DCN REISSUED TO CORRECT DRAWING REV LETTERS

DCN No. **E970061-01-D**

DOCUMENT CHANGE NOTICE (DCN)

DOCUMENT No. (DOC-REV-GP. ID)	TITLE	NEW REV.
D961419-A-D	Large Core Optic Component Carrier Cover Assembly	B
D961420-A-D	Beam Splitter Optic Carrier Cover Assembly	B
D961425-B-D	Core Optic Component Carrier Base Assembly	C
D961450-A-D	Core Optic Component Carrier Top Plate Assembly	B
D961468-A-D	Core Optic Component Carrier Metrology Interface Top Plate Assembly	B

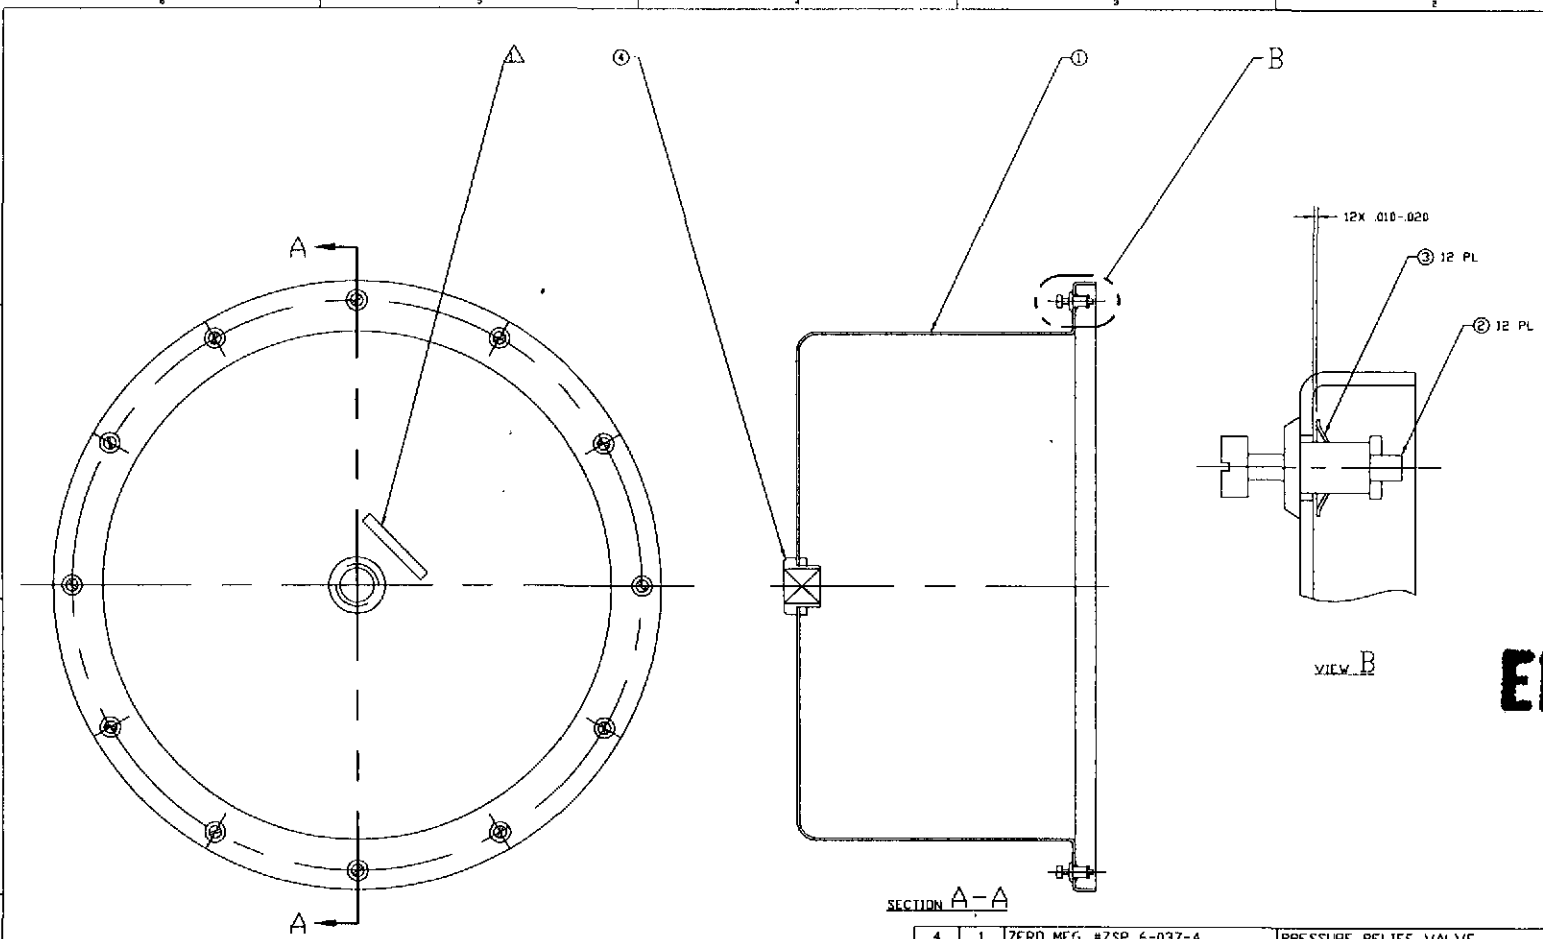
Changed text of delta note 1 from:

Stamp serial number approx. where shown using indelible black ink, 3/16 inch high lettering.

to:

Mark serial number approx. where shown by engraving, die stamping, or other permanent method, 1/4 inch high lettering.

NOTES: UNLESS OTHERWISE SPECIFIED:
 ▲ MARK SERIAL NUMBER APPROX. WHERE SHOWN BY ENGRAVING, DIE STAMPING, OR OTHER PERMANENT METHOD, 1/4 INCH HIGH LETTERING.
 ▲ FOR VENDOR INFORMATION, SEE TOP ASSEMBLY MATERIALS LIST D961419 OR D970007.

LIGO CALIFORNIA INSTITUTE OF TECHNOLOGY
 MASSACHUSETTS INSTITUTE OF TECHNOLOGY
 CORE OPTIC COMPONENT CARRIER
 BASE ASSEMBLY
 DRG. NO. D961425-C-11
 SHEET 1 OF 1

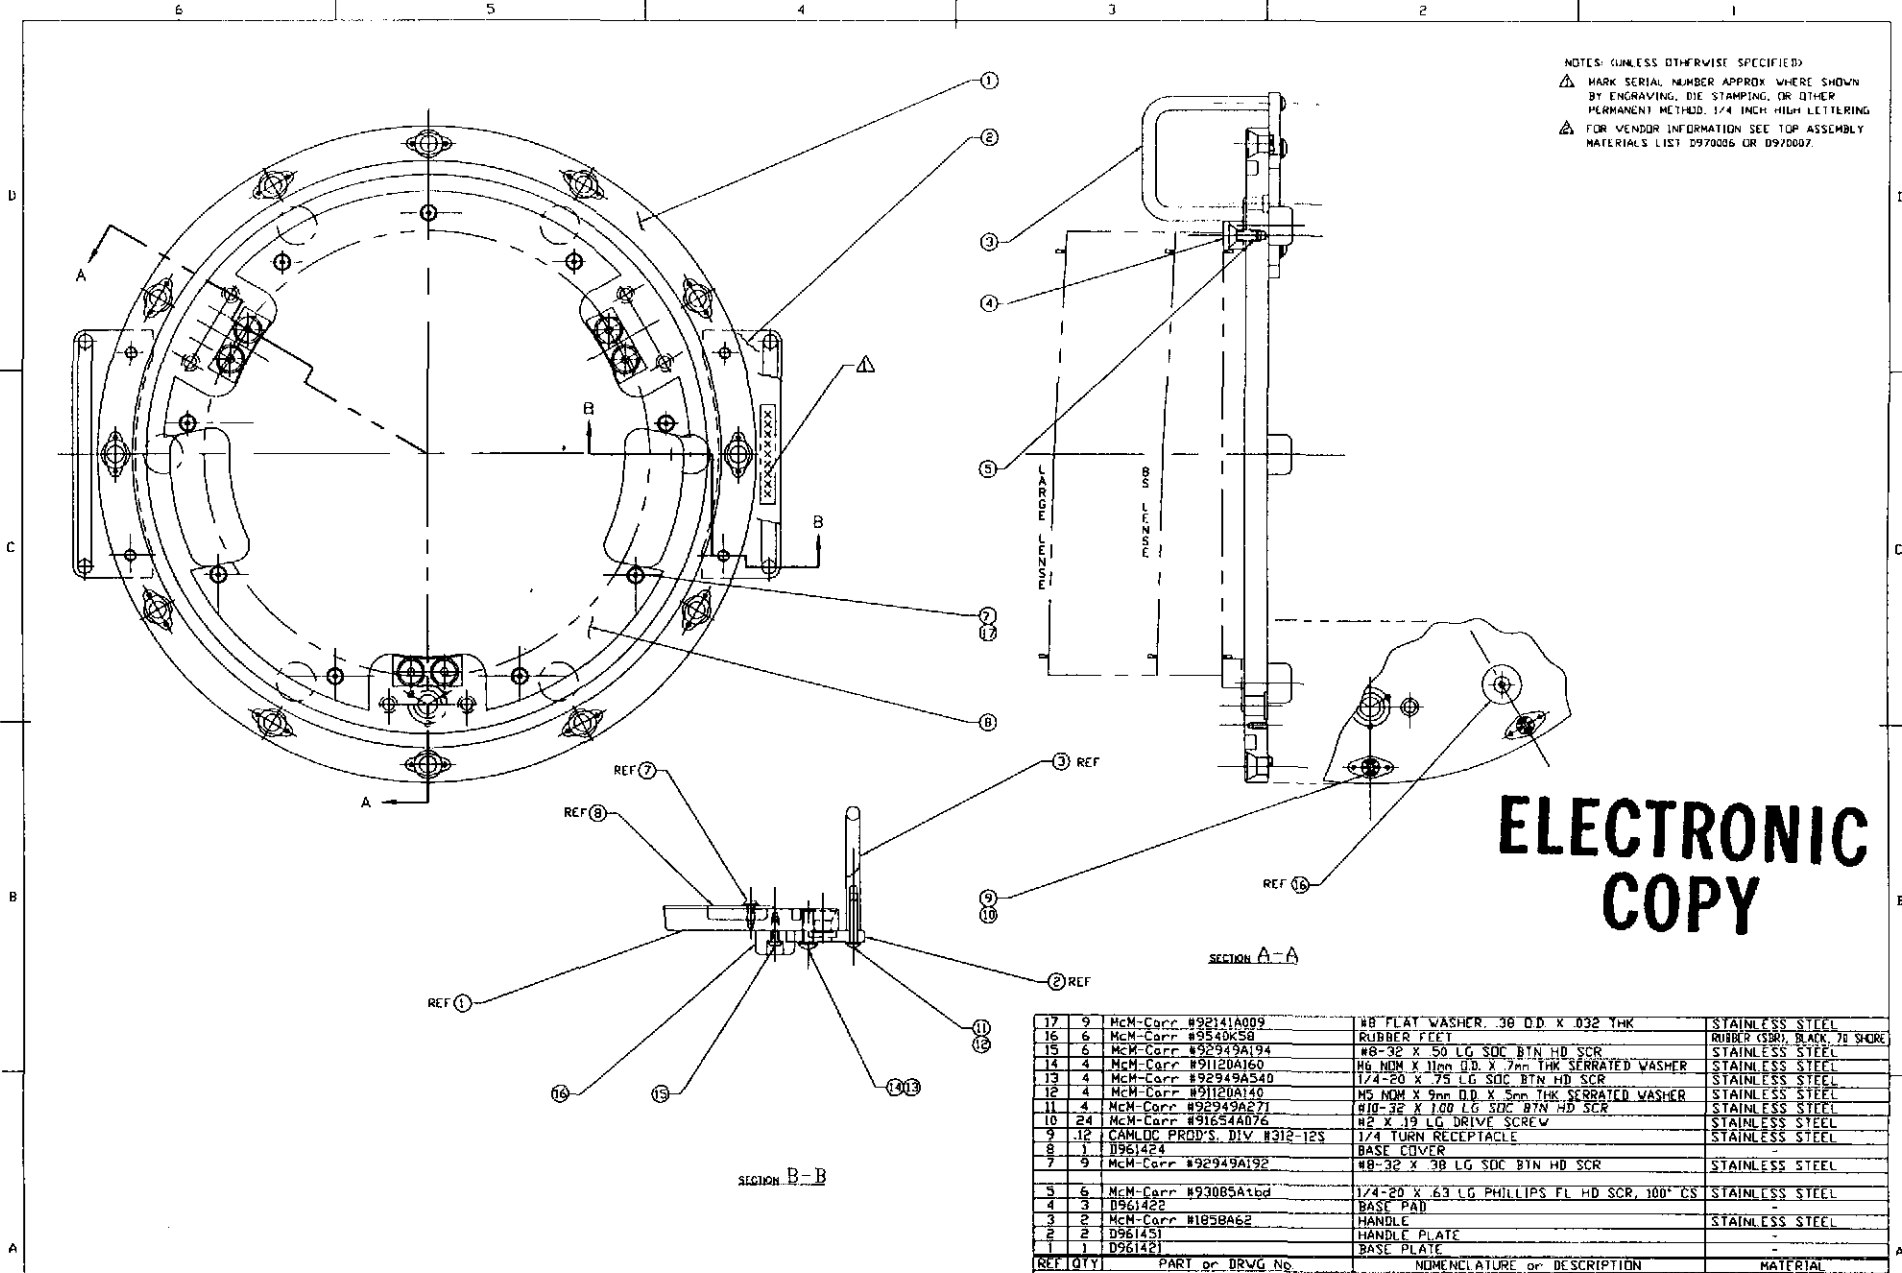
Changed text of delta note 1 from:

Stamp serial number approx. where shown using indelible black ink, 1/4 inch high lettering.

to:

Mark serial number approx. where shown by engraving, die stamping, or other permanent method, 1/4 inch high lettering.

Pictorially updated to include pocket features added to part D961421 (base plate), and matching cut-out feature added to part D961424 (teflon base cover).

NOTES: UNLESS OTHERWISE SPECIFIED:
 ▲ MARK SERIAL NUMBER WHERE SHOWN BY ENGRAVING, DIE STAMPING, OR OTHER PERMANENT METHOD. 1/4 INCH HIGH LETTERING.
 ▲ FOR VENDOR INFORMATION SEE TOP ASSEMBLY MATERIALS LIST D970006 OR D970007.
